To: Sperian Fall Protection Distributors
From: Sperian Fall Protection
Date: 12/30/2010
Subject: Stop Use and Repair Notice (*Immediate Attention Required*)

- Miller StopFall Fall Restraining System
- Model 7600A/YL (All Models)

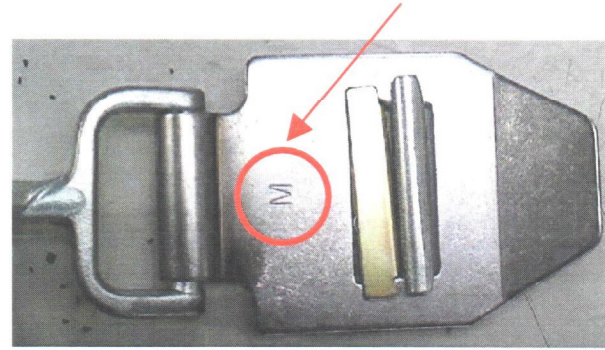
The following issues are what we will be looking for to determine whether or not the StopFall Unit will need to be repaired:

Also, when the units have been inspected and approved for service, an "M" has been stamped on the outside portion of the plate (see below). If you do not see an "M" on the product, it will need to be inspected.
